SUBJECT: Springfield Review of Completed Land Developments for SALDO Design Standards

In advance of our meeting next week I have prepared another review of selected land developments for our discussion prior to working on updating the design standards article in the SALDO. The purpose of this review is to examine recently completed land developments in the township to discuss potential improvements to design elements regulated in the ordinance. For our meeting next week we will review the following developments and I have attached a document that contains some notes and suggestions to be utilized during our discussion.

Re: 17-0170-001
Plan Name: Early Learning Center/School District of Springfield Township
72,000 sq. ft./11.5 acres
Situate: Paper Mill Road (W)/Montgomery Avenue (N)
Springfield Township

Re: 17-0171-001
Plan Name: Springfield Township High School
(18,621 sq. ft./43.58 acres)
Situate: Paper Mill Road (W) and Fraser Road (N)
Springfield Township

Springfield Township School District Early Learning Center (Paper Mill Rd/Montgomery Ave)

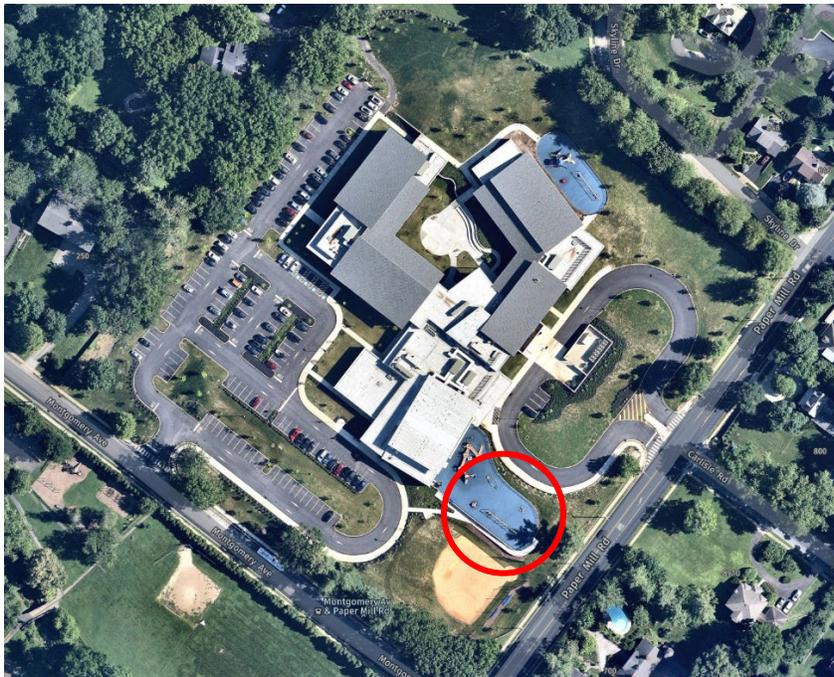
- Sidewalks: Maintained existing sidewalks around site and improved crosswalks across access drives.
- This project also generally has good internal sidewalks and connections around the school site and parking lot. This is something that is not currently mentioned/required in the current SALDO, but could be added. Possible language includes: “Provisions for pedestrian safety within a parking lot shall be required by providing sidewalks, delineated crosswalks, traffic calming devices, and other measures.”
- County review letter requests the sidewalk to continue from play area to bus loop to further improve internal pedestrian circulation. This suggestion does not appear to have been implemented based on current aerials of the site.
- Development maintained easement and trail connection at the rear of the school to Yeakel Avenue

Suggested sidewalk connection not implemented in final design

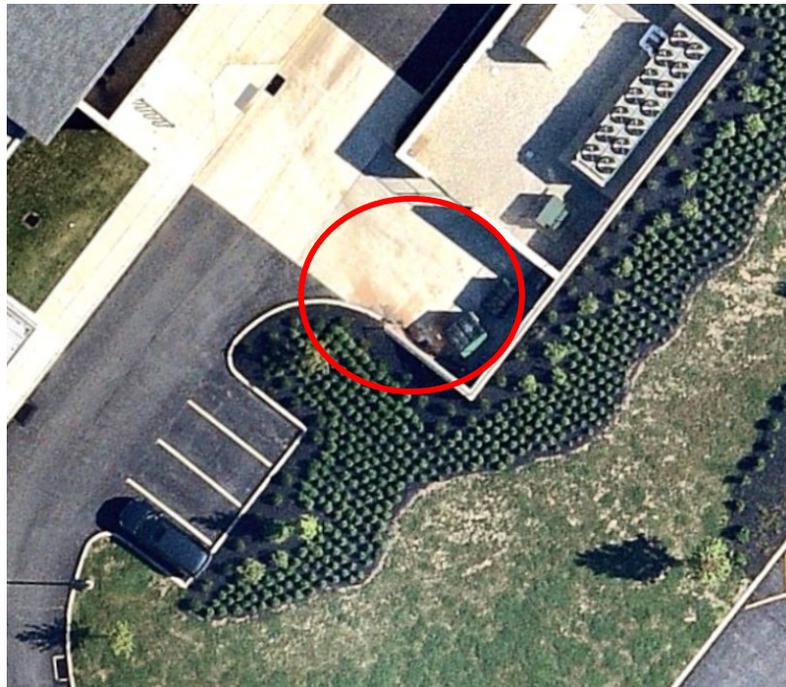
- While visually screened from the road, the dumpsters on site within the bus loop do not appear to be fully enclosed. This is something we could consider adding to ensure that the entire perimeter is screened from view.
- Example language for this includes:
 1. *“Landscape and screening buffers shall be required in the following locations:

Dumpster area not screened from building
